REGULATORY INFORMATION DISTRIBUTION SYSTEM (RIDS)

SUBJECT: Application for amends to Licenses DPR-31 & DPR-41, replacing Tech Specs w/TS submitted w/util 860929 & 1128 ltrs.

L-89-201
10 CFR 50.90

Re: Turkey Point Units 3 and 4
Docket Nos. 50-250 and 50-251
Proposed License Amendment
Revised Technical Specifications

FIGURE 5.1-1 SITE AREA MAP

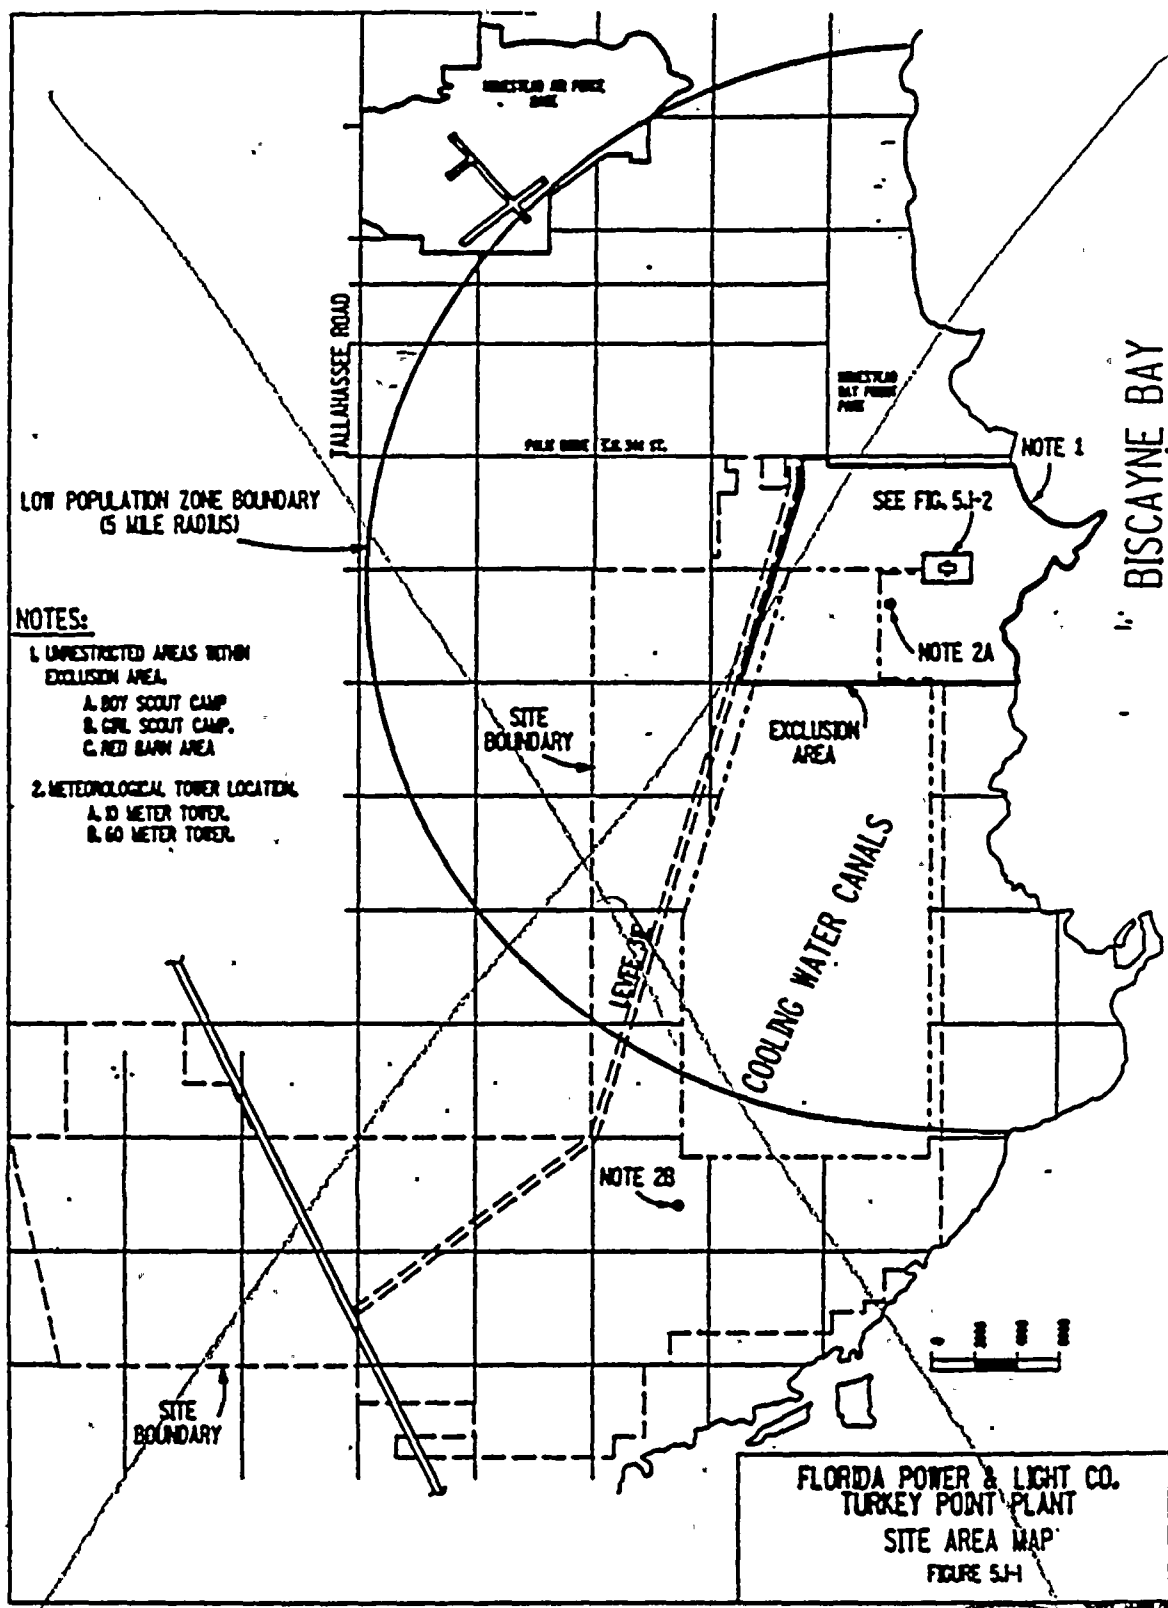
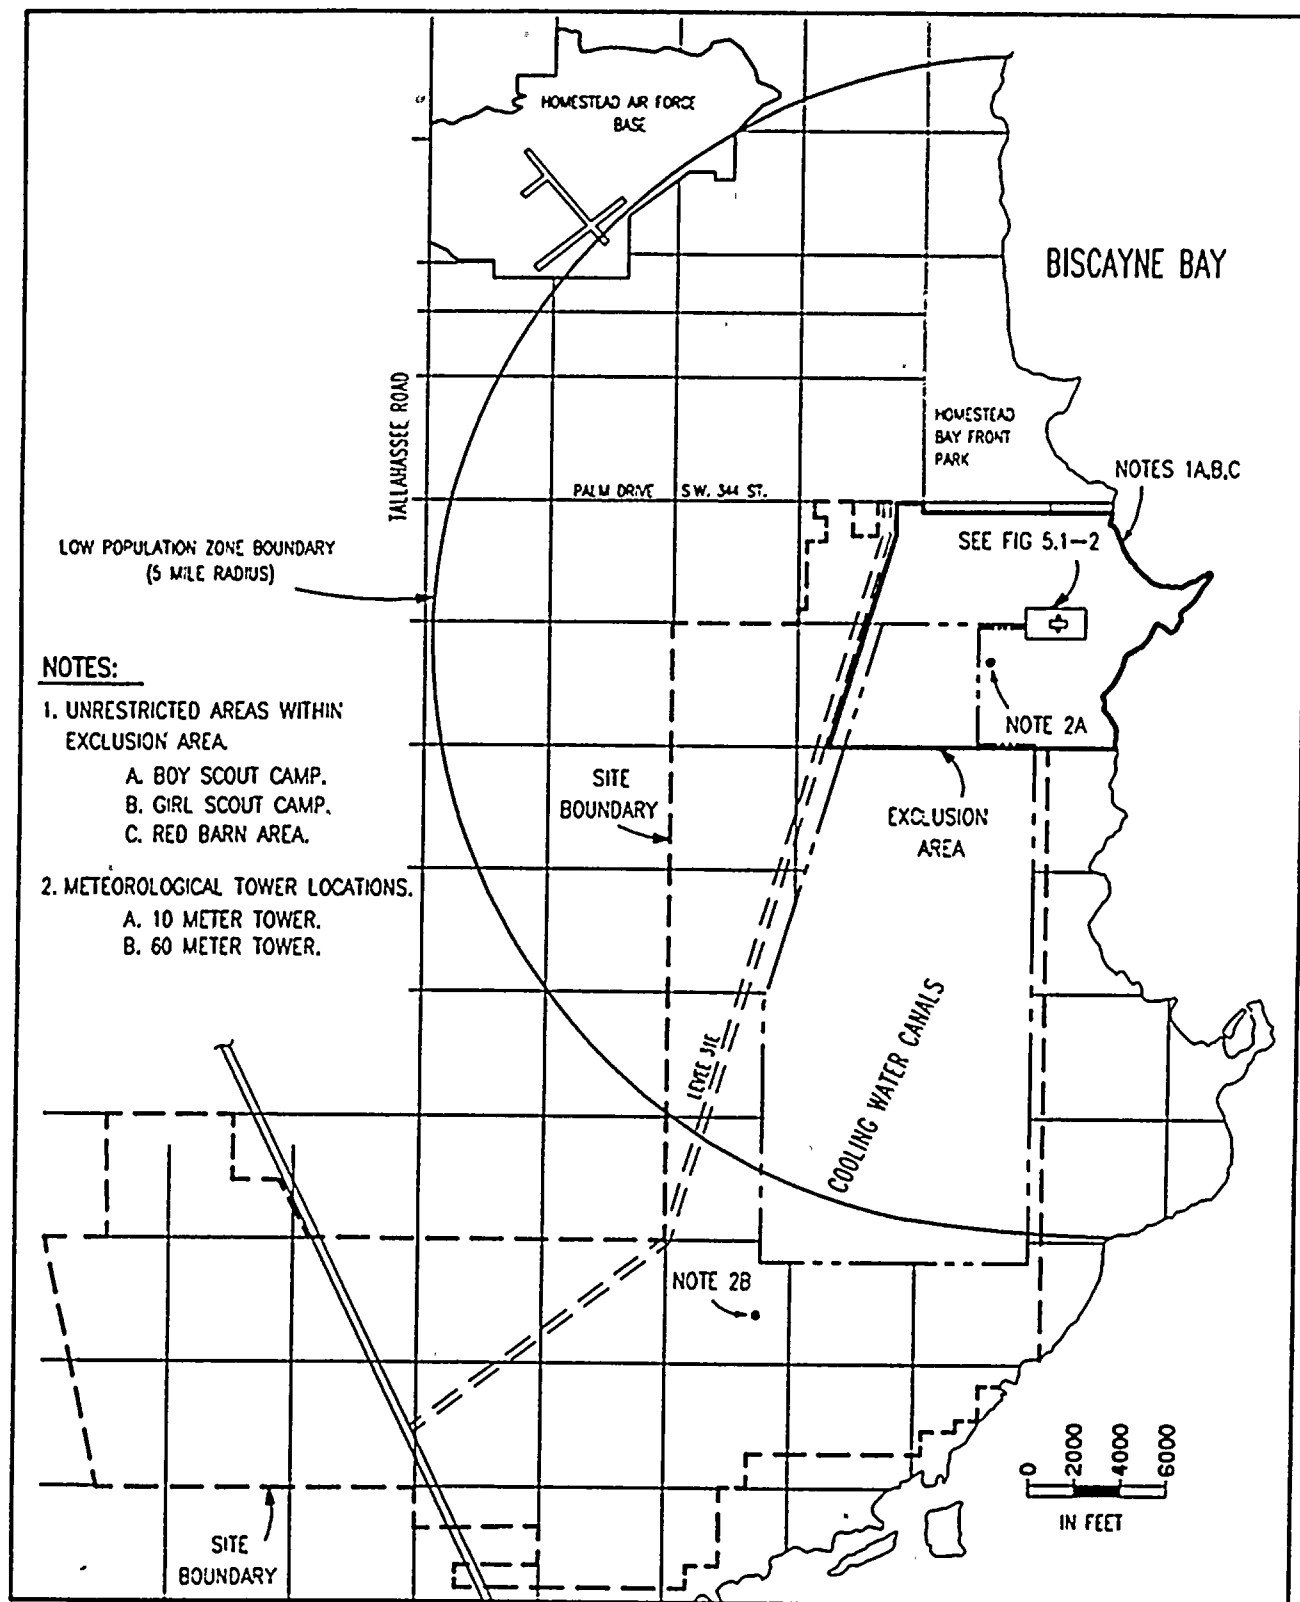
The locations of the Meteorological Towers are identified in the revised Specification Figure 5.1-1. Addition of this information is consistent with the Standard Technical Specification.

- 1) The proposed change as described in Item 2.a is similar to example (ii) of 48 FR 14870 in that it provides additional design information by including Meteorological Towers locations in the revised Technical Specification Figure 5.1-1.

5.5.1 The meteorological towers shall be located as shown on Figure 5.1-1.
